Re: Powertech (USA) Inc.'s Response to the Request for Additional Information to Support the Environmental Review of its Application for a Nuclear Regulatory Commission Uranium Recovery License for its Proposed Dewey-Burdock In Situ Leach Uranium Recovery Facility in the State of South Dakota
Docket 040-09075, TAC No. J 00533

**Response to U.S. Nuclear Regulatory Commission
Request for Additional Information
Powertech (USA) Inc. Dewey-Burdock Project
Environmental Review of Application for a U.S. Nuclear
Regulatory Commission Source
Material License**

**Response to the U.S. Nuclear Regulatory Commission's (NRC)
Request for Additional Information for the
Dewey-Burdock Uranium Project
Environmental Report Submitted August 11, 2009.**

PowerTech (USA) Inc.
ER_RAI Figure AQ-1
Air Quality Receptor Locations

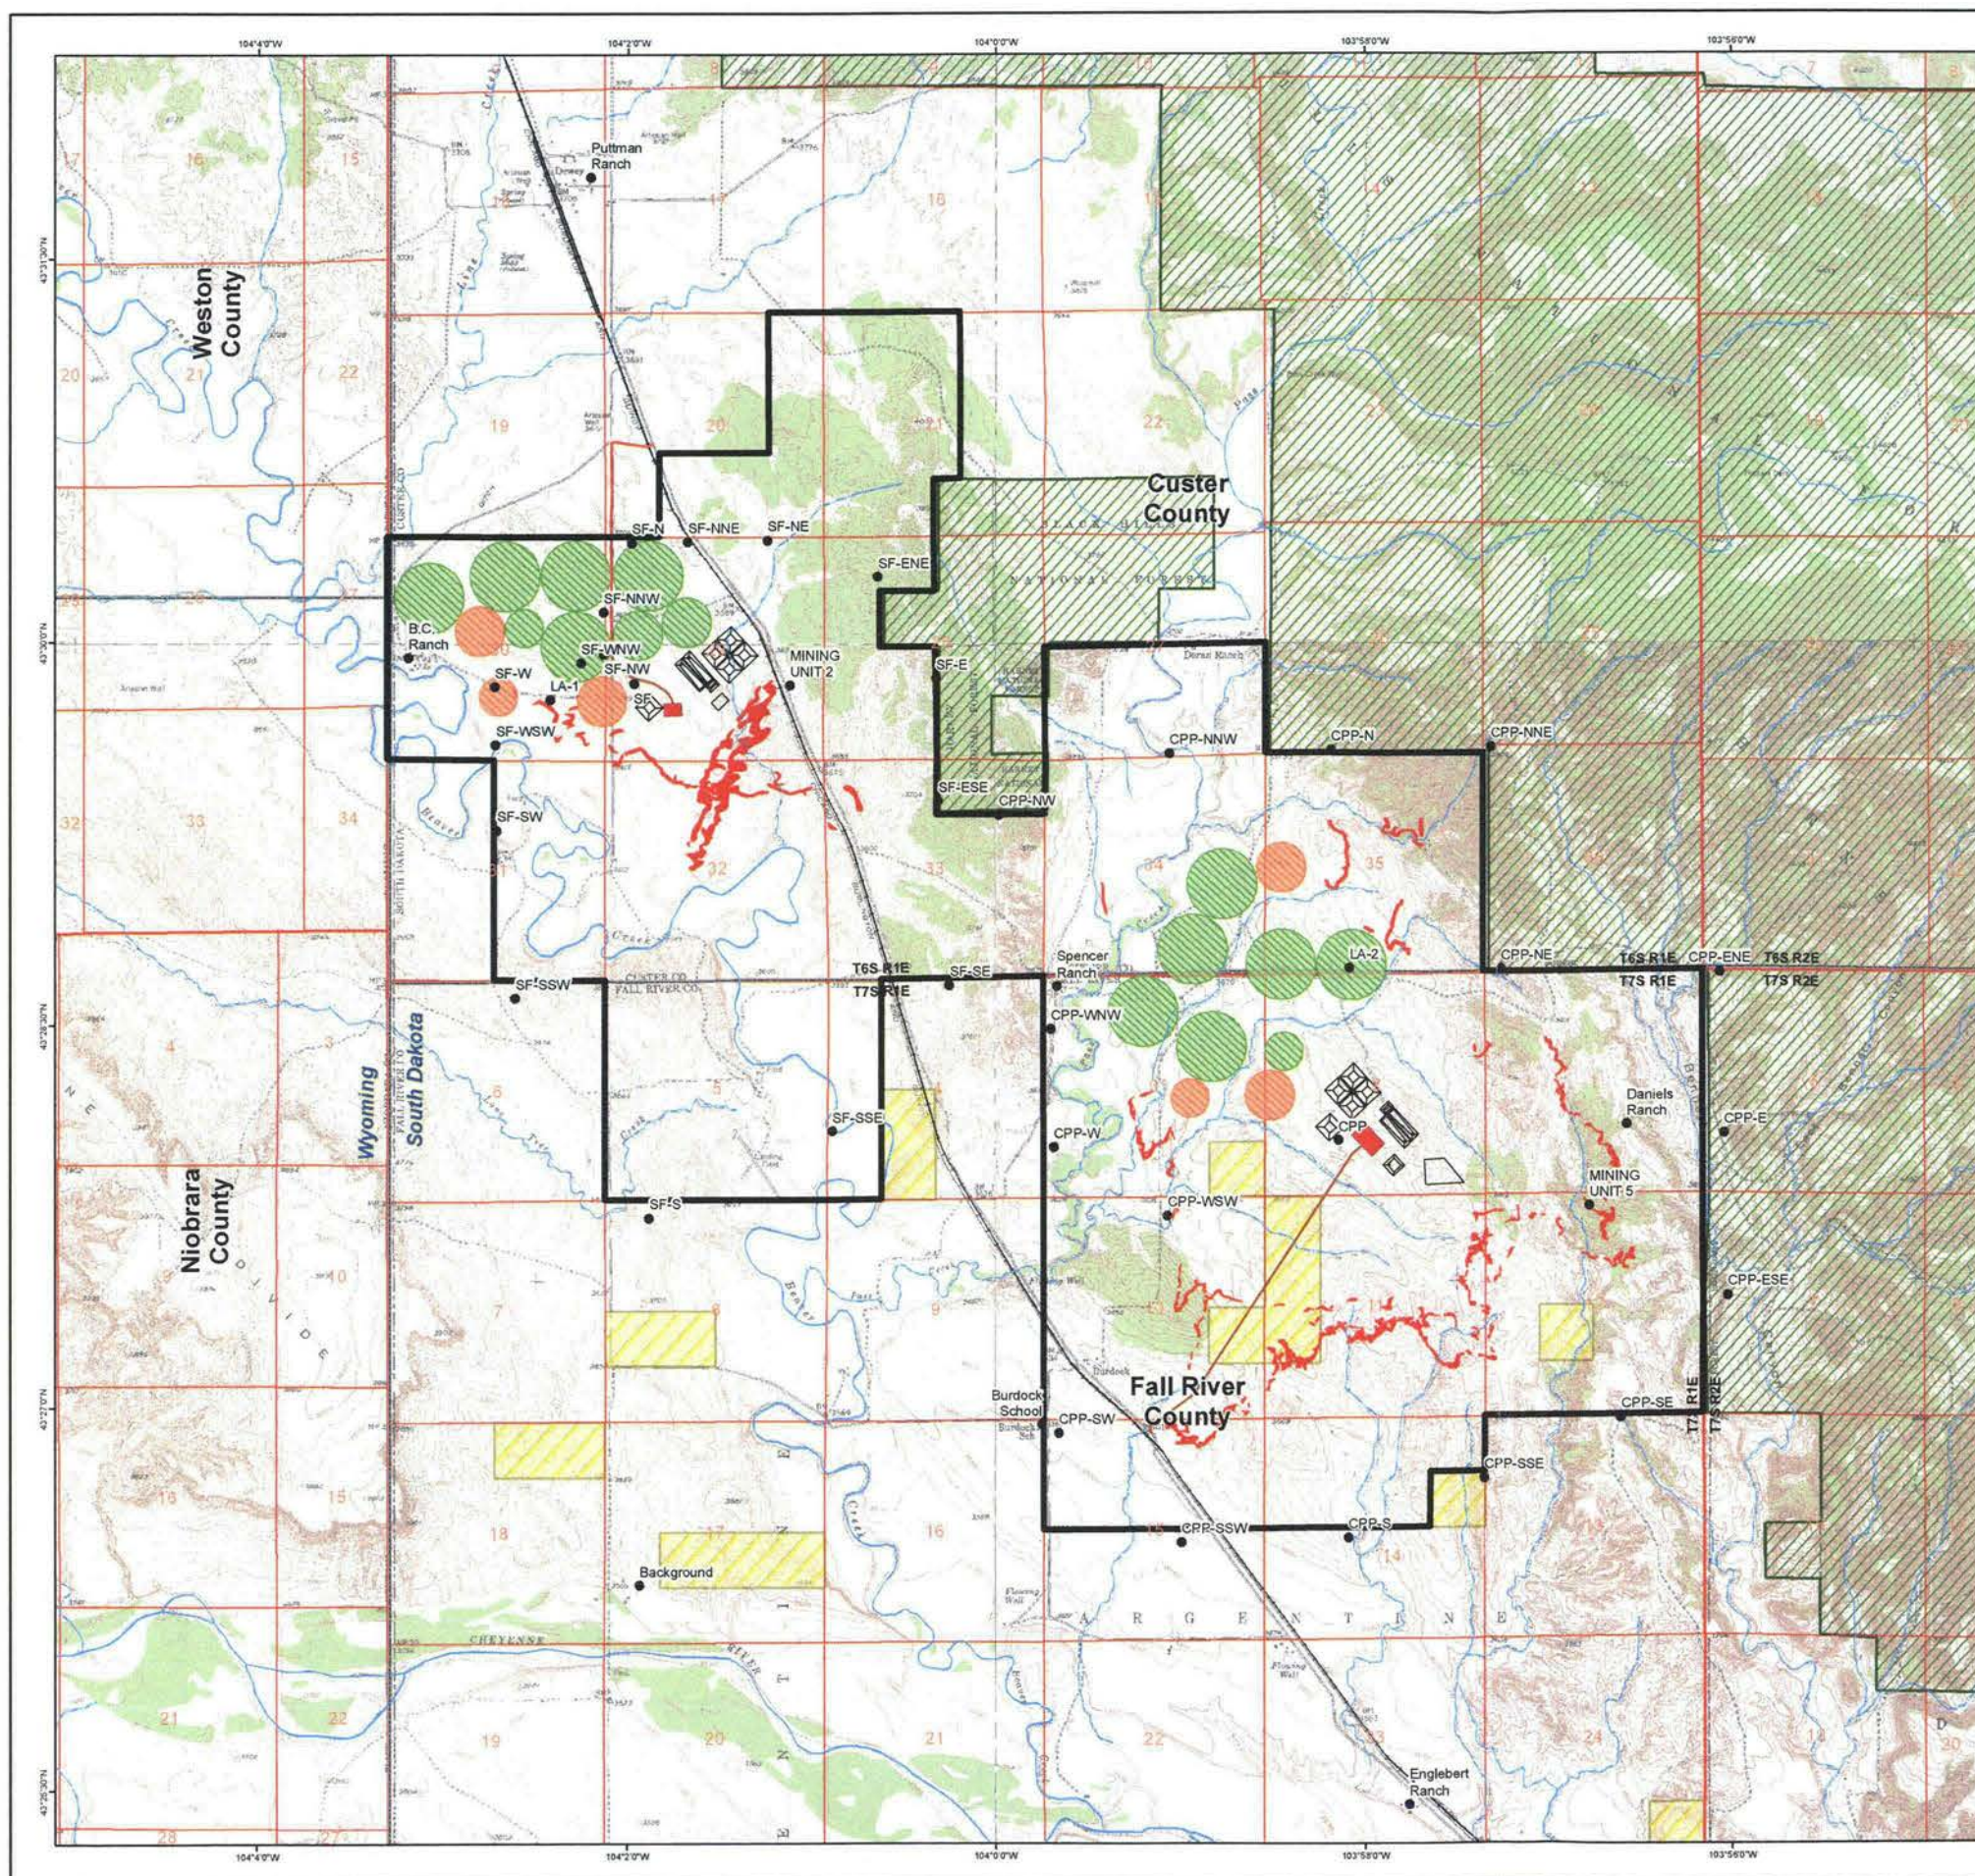
Clarify the description of fugitive dust emission estimates.

- 1. Powertech should clarify whether traffic from commuting workers was included in the fugitive dust emissions estimates, and if it was not, either provide an updated estimate that includes commuting worker traffic or provide the basis for excluding the information.*
- 2. Powertech should clarify whether the fugitive dust estimates for the operational period include activities that would be conducted for the aquifer restoration phase. This information is needed for the staff to evaluate the potential impacts of fugitive dust emissions.*

The results of modeling indicate that National Ambient Air Quality Standards (NAAQS) will not be exceeded at any of the receptor sites as shown in **ER_RAI Figure AQ-1.**

ER_RAI Figure WR-3.1: Location of Confined Portion of the Fall River Aquifer

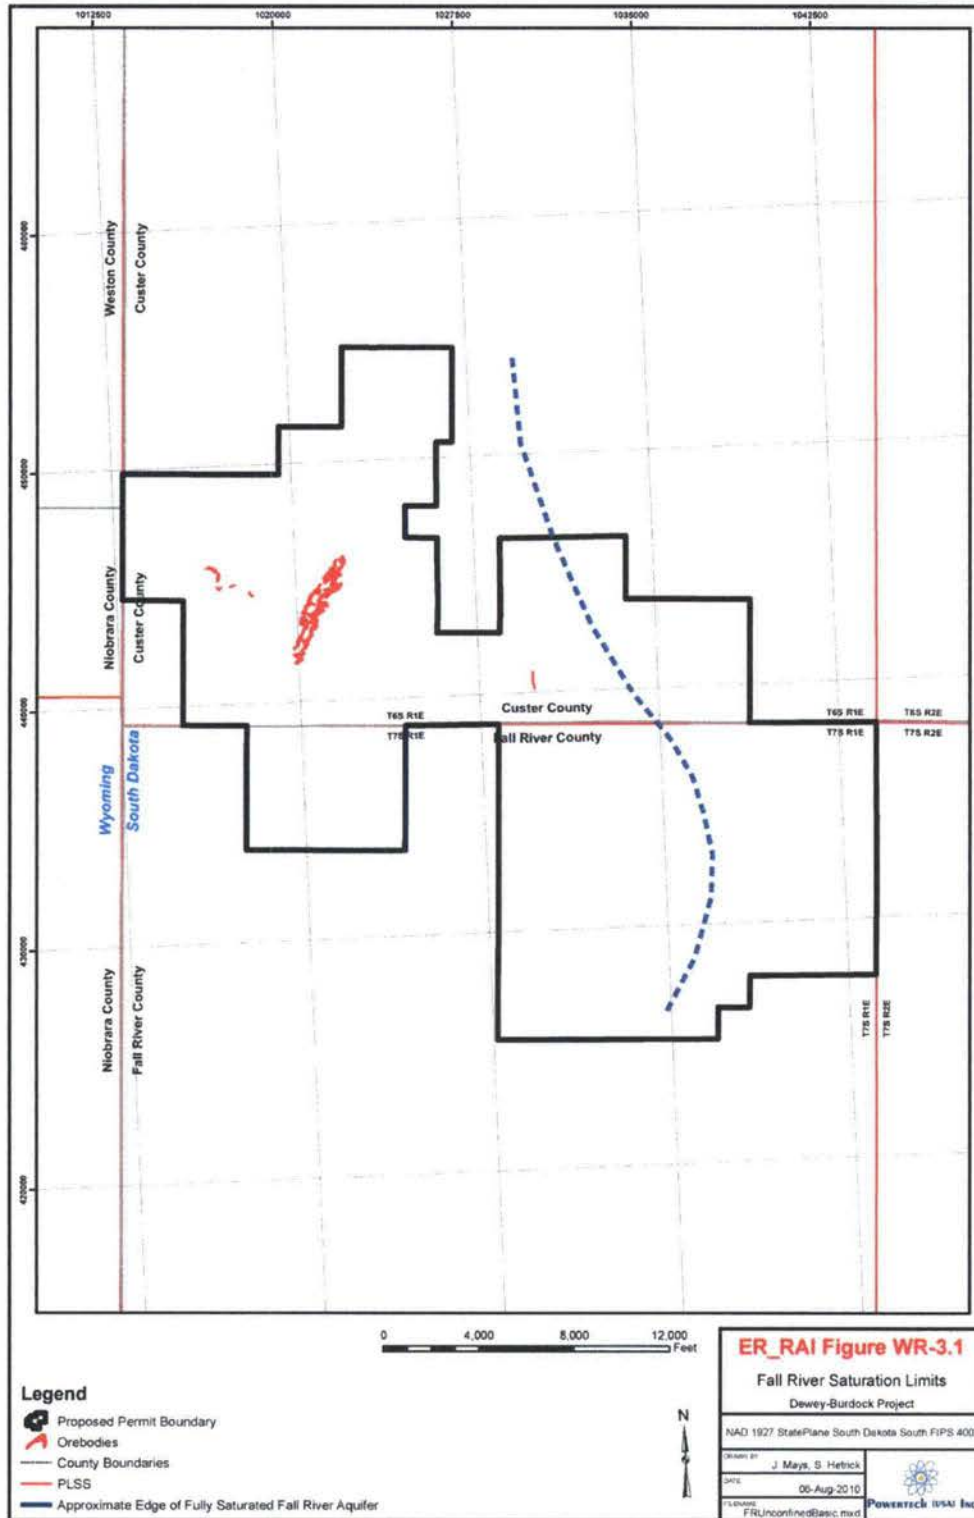
Provide information on ISR operations in unconfined portions of the Lakota and Fall River aquifers in the Burdock portion of the project area.

1. Whether Powertech plans to conduct ISR operations in unconfined portions of the Lakota and Fall River aquifers in the Burdock area identified during delineation drilling and aquifer pump testing.

Proposed activities relative to estimated unconfined zones in the Fall River and Lakota aquifers are depicted in **ER_RAI Figure WR-3.1** and **ER_RAI Figure WR-3.2** respectively. The figures have a dashed-line estimating the approximate location at which each aquifer becomes saturated moving away from the outcrop where the potentiometric surface is at the same elevation as the top of the formation. The estimated boundary is approximated using the intersection of the potentiometric surfaces generated from water level measurements and the top structure contour of each respective aquifer and thus not highly accurate, and not confirmed with many data points. More precise measurement of the unconfined portions will be determined during an additional hydrogeological investigation prior to well field development. For the initially proposed well fields, Burdock Mine Unit I, and Dewey Mine Unit I, conditions are well confined with water levels several hundred feet above the top of each aquifer and confined conditions measured in aquifer pump tests.

Powertech (USA) plans for ISL operations within potentially unconfined portions are limited to the eastern side of the project in portions of Burdock Mine Unit II and Burdock Mine Unit IV in the Lakota Formation. Though ore bodies are present in unconfined portions of the Fall River formation on the eastern side of the permit area, Powertech (USA) does not propose to mine in those Fall River ore bodies in this license application. Furthermore, Powertech (USA) has limited its proposed operations in the Fall River Formation to the Dewey portion of the project. **Supplement Exhibit 3.1-4 Revised** "Future Mine Units" depicts ore bodies which Powertech (USA) plans to mine in the project.

ER_RAI Figure WR-5.1: Distribution of Water Rights within the Madison Aquifer.

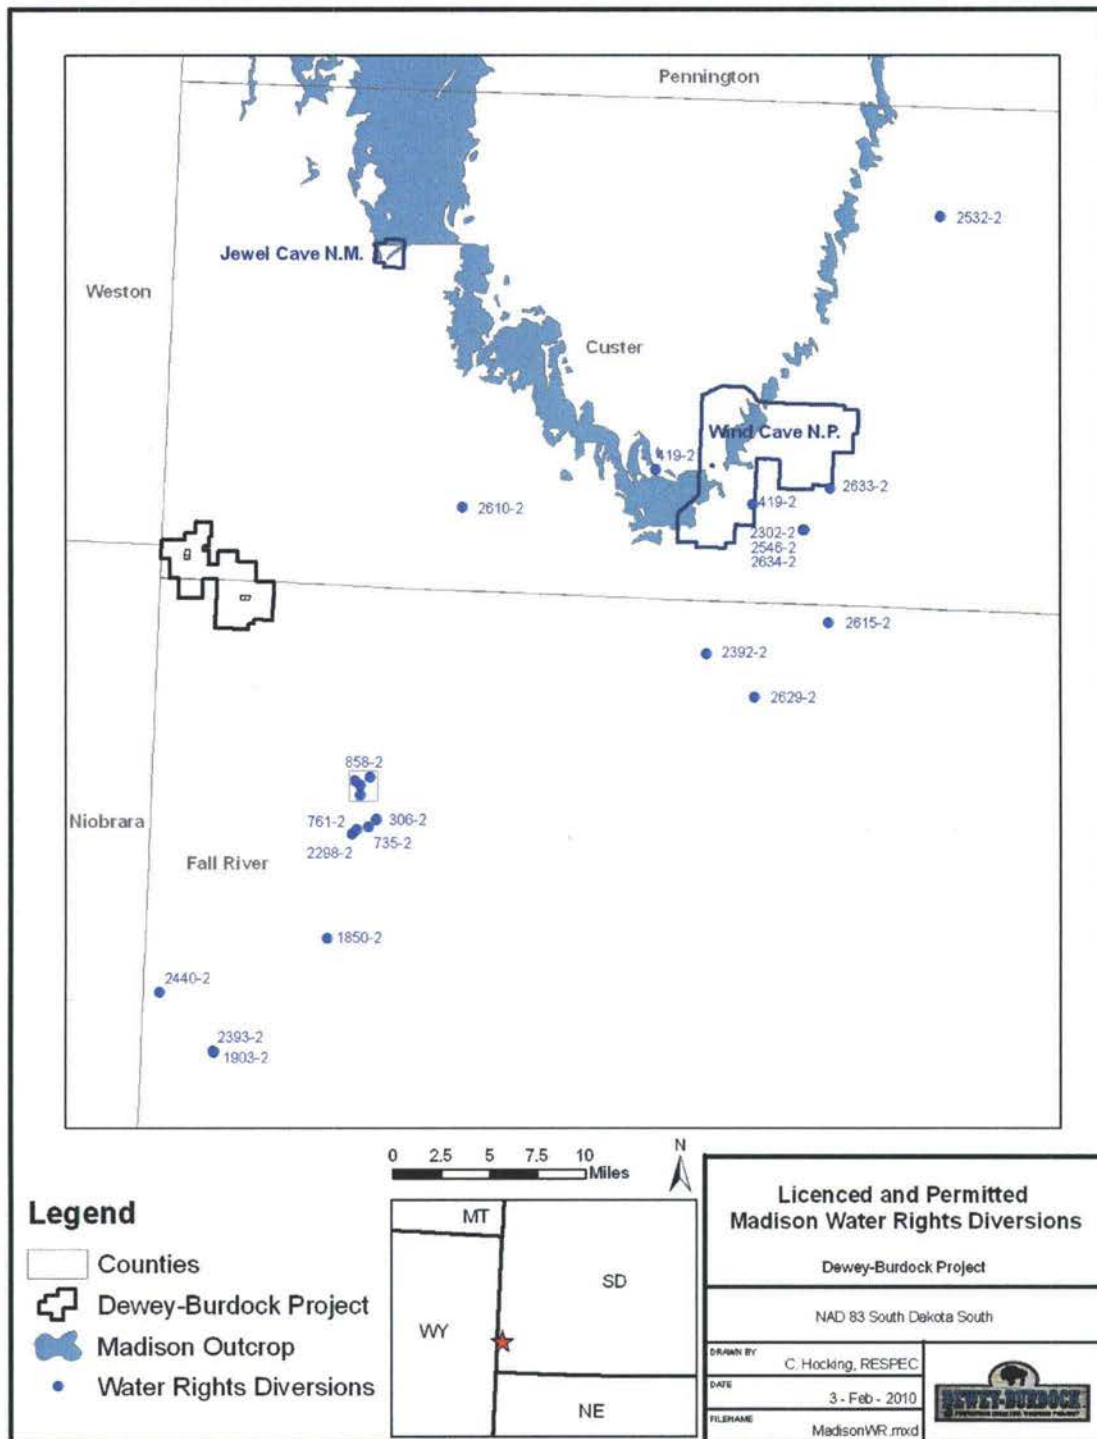
Provide information on the status of obtaining water appropriation permits for use of water from the Madison aquifer.

- 1. Please provide information on the status of obtaining a water appropriation for use of Madison aquifer water during operations and aquifer restoration.*
- 2. If water rights permit cannot be secured for the Madison aquifer provide information on the potential alternatives to meet water requirements during operations and aquifer restoration and how each alternative would impact groundwater levels, flow rates, and flow directions.*

The water rights application is planned to be submitted to DENR during 2010. There is currently limited use of the Madison water within the immediate vicinity of the project area and sufficient availability to meet the needs of the project. There are no reasons to expect that the permit would not be accepted and it is believed that the proposed project meets all acceptable criteria for obtaining a permit.

Figure SOC-1.1: Unemployment Rates, Wyoming, 2000 – 2009

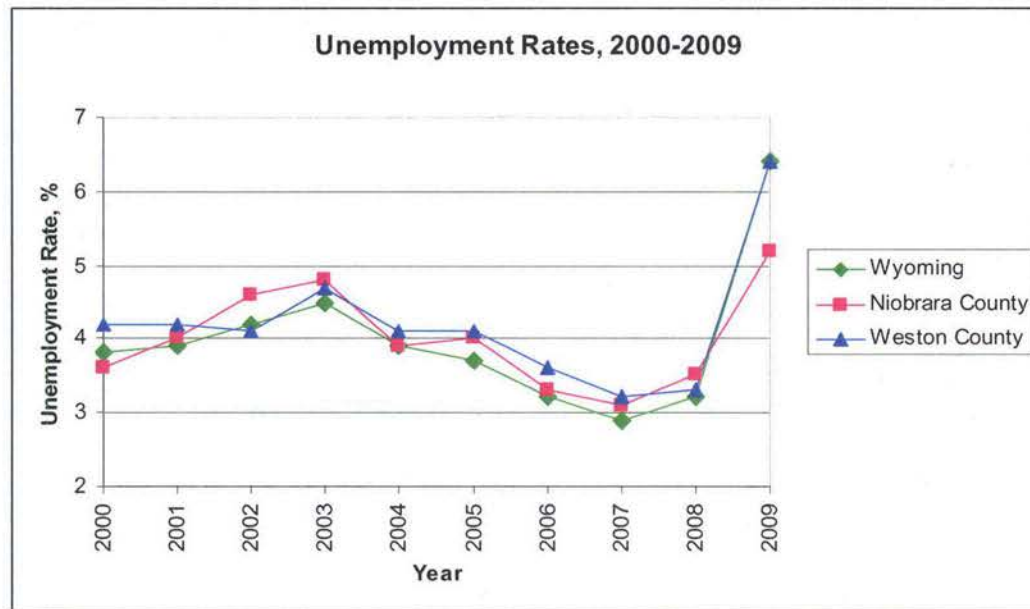
- 2. Provide annual average labor, employment, and income characteristics for direct social zones within the region of interest for Wyoming, similar to data provided in ER Section 3.10.3 for South Dakota.*

Unemployment trends for Niobrara and Weston Counties and Wyoming's state-wide rate over the last decade are presented in **Figure SOC-1.1**, which plots the average unemployment rate for each year determined from monthly county and state data provided by the WDE's Local Area Unemployment Statistics (LAUS).

As the figure shows, the average unemployment rates have remained similar between the Counties of Niobrara and Weston and the State of Wyoming. No major disparities between county and state trends have occurred in the last decade.
